工程指示 / 要求簡箋(E.I.)

工程指示編號：EI / 517⁹ / 22

工程名稱：將軍澳日出康城 11

工程項目：後裝門窗 塞泥 詳細資料分判

SK-01

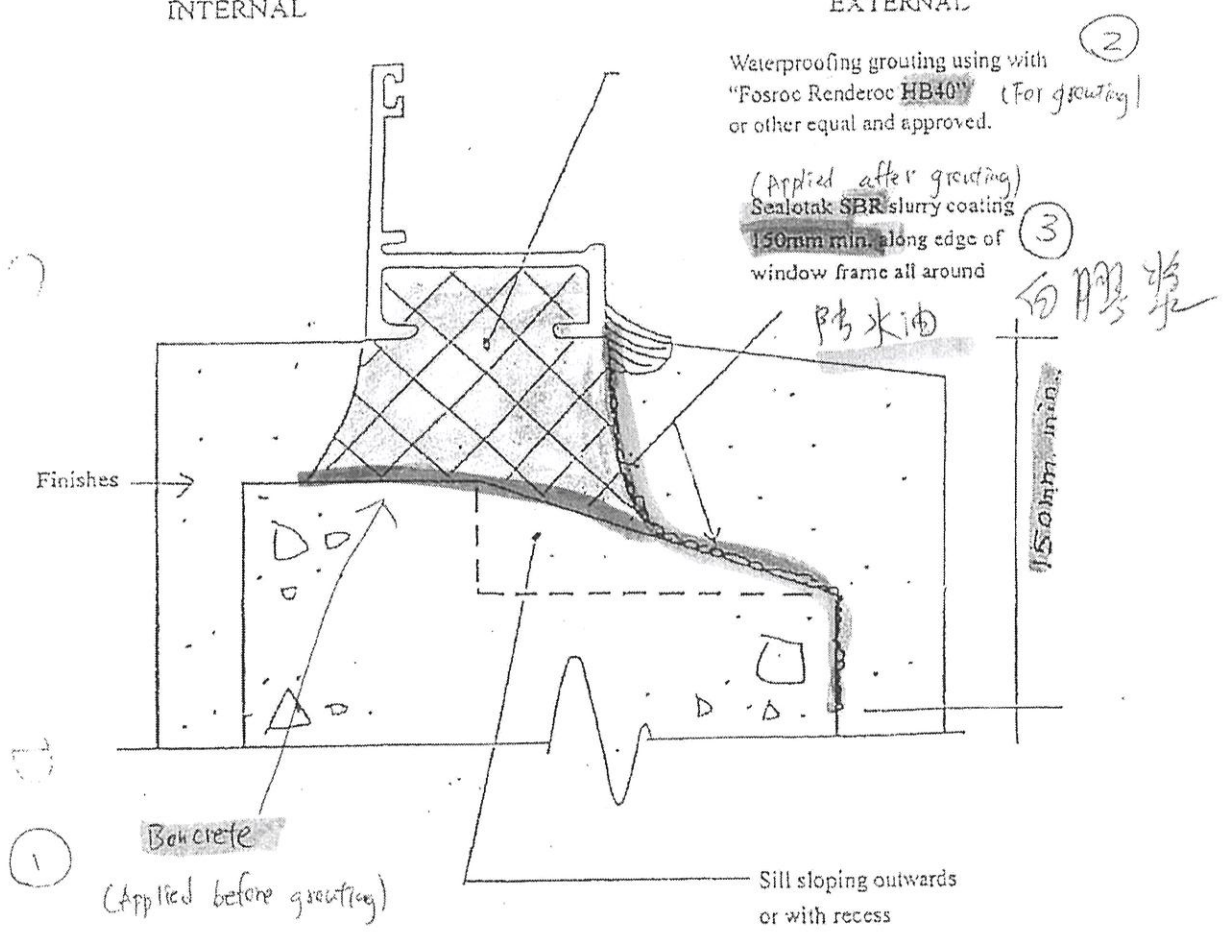
提供塞泥詳細資料 後裝窗(MC41330) / 趟門 按露台數量計算後裝窗：四邊塞泥趟門：左右兩企塞泥，頂底為防水片不用塞泥請使用做合約。請留意：防水物料已訂 見 EI4971謝謝！請在 2022.10.14 前完成上列要求。

ELEVATION FOR SLIDING DOOR

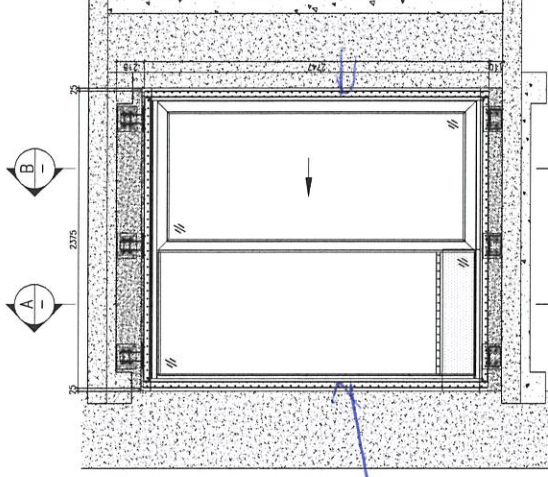
顶底不用窗泥

顶底不用窗泥
